REGIONAL REVIEW FINDING

RE: Development of Regional Impact (DRI) Review

Name of Proposal: 2023 Chastain Meadows DRI 3940

<u>Description</u>: A DRI review of a proposal to construct a mixed-use project with 425,000 SF of light industrial space in three buildings, 140 townhomes, 220 age-restricted multifamily units, 22,500 SF of restaurant space, and 7,500 SF of retail space on an approximately 57-acre wooded site located on Chastain Road in unincorporated Cobb County.

DRI SITE PLAN

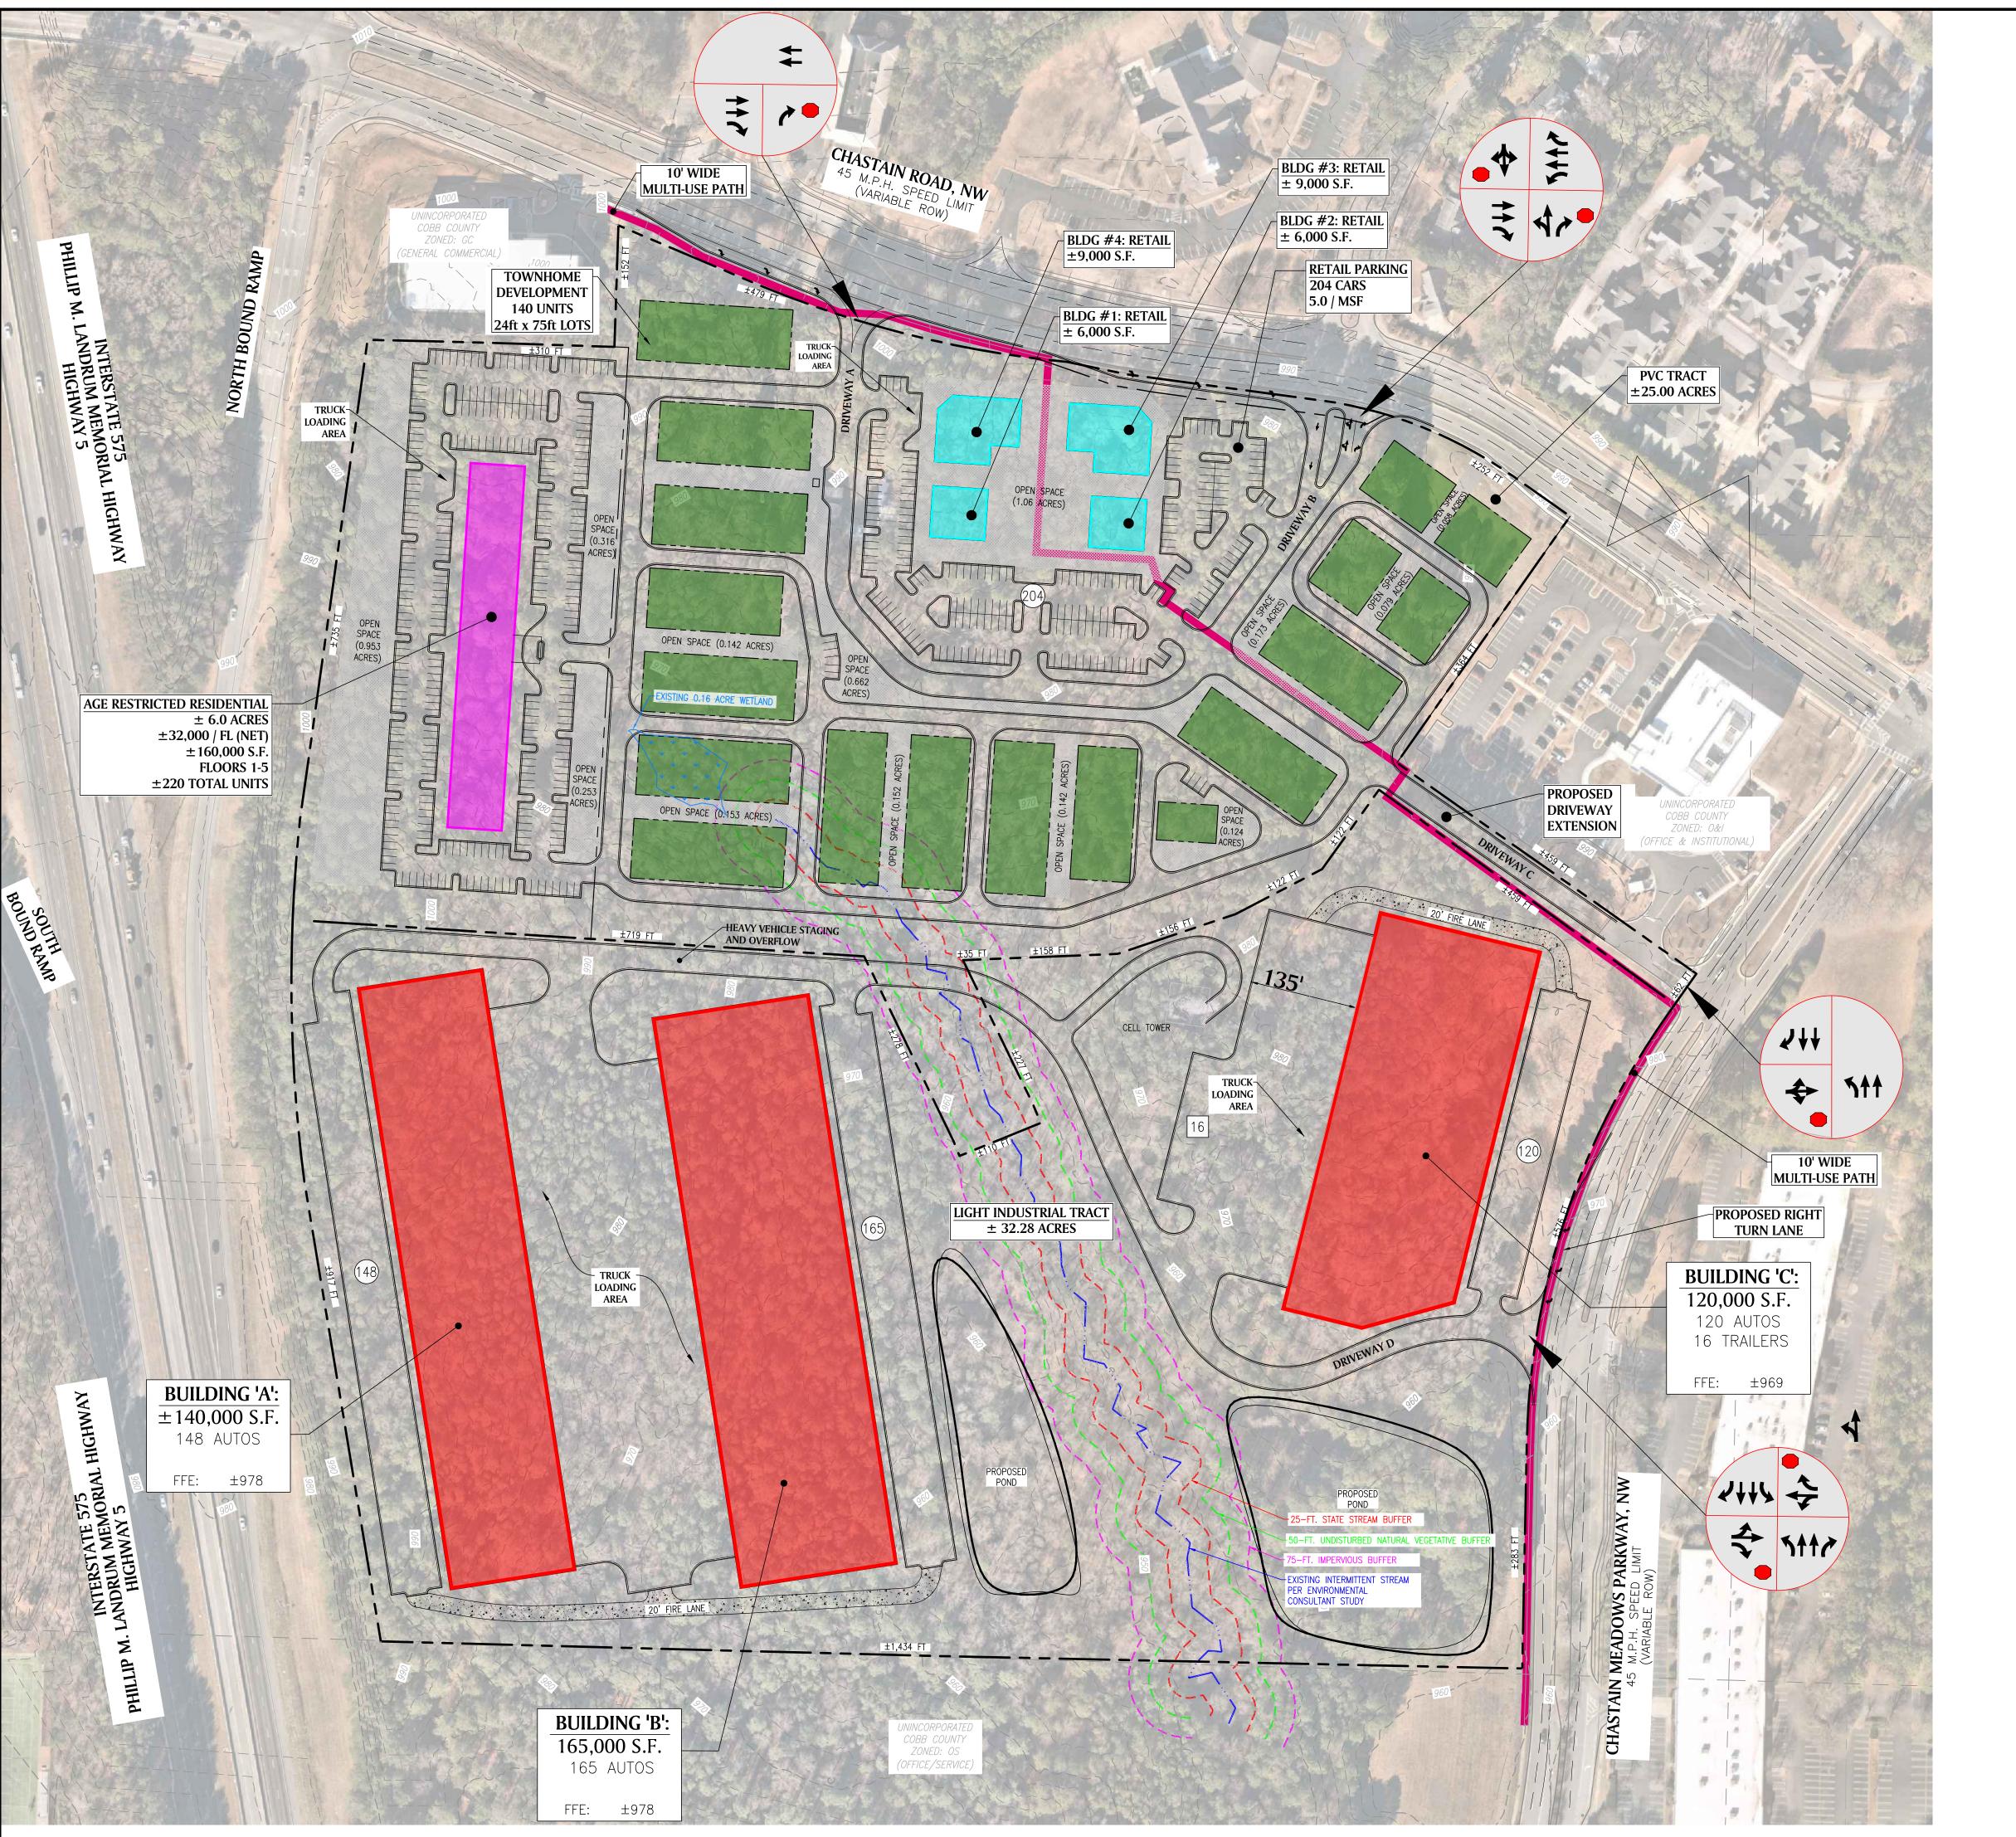
The project will remove a wetland area and a significant portion of the stream shown on the project site plan including the stream headland which is not supportive of regional environmental policies.

A planned multi-use trail is shown along Chastain Road and then traversing the interior of the site to connect to Chastain Meadows Road. The proposed route would provide trail users with access to retail amenities and activate the site which is strongly supportive of regional multi-modal transportation and urban placemaking policies. A sidewalk will still need to be provided along the trail's originally planned route along Chastain Road to the east.

The USGS coverage for the project area shows no streams on or near the property. However, the submitted site plan shows a stream originating in the northern portion of the project property and running south—southeast through the property. The County 50–foot undisturbed buffer and 75–foot impervious setback, as well as the 25–foot State Sediment and Erosion Control buffer are shown and identified. The submitted plan shows townhouse structures and associated driveways built over the stream headwaters, as well as one access road crossing the stream and a portion of the proposed southeastern detention pond intruding into the 75–foot setback. The stream crossing is exempt under the County Stream Buffer Ordinance and the need for a variance for the detention pond will depend on what is done in the setback. The townhouses

The project also proposes the removal of wetlands and a significant portion of the stream located in the site which is not in keeping with regional environmental policies. Ideally the building footprints could be adjusted to limit the significant negative wetland and steam impacts, to provide additional open space/retained wooded area, and to consolidate the existing space provided in order to better retain some of the existing trees. The construction approach should further attempt to retain existing trees wherever possible.

The central undeveloped space between the warehouse building footprints adjacent to the stormwater ponds presents an opportunity to create a functioning natural area.
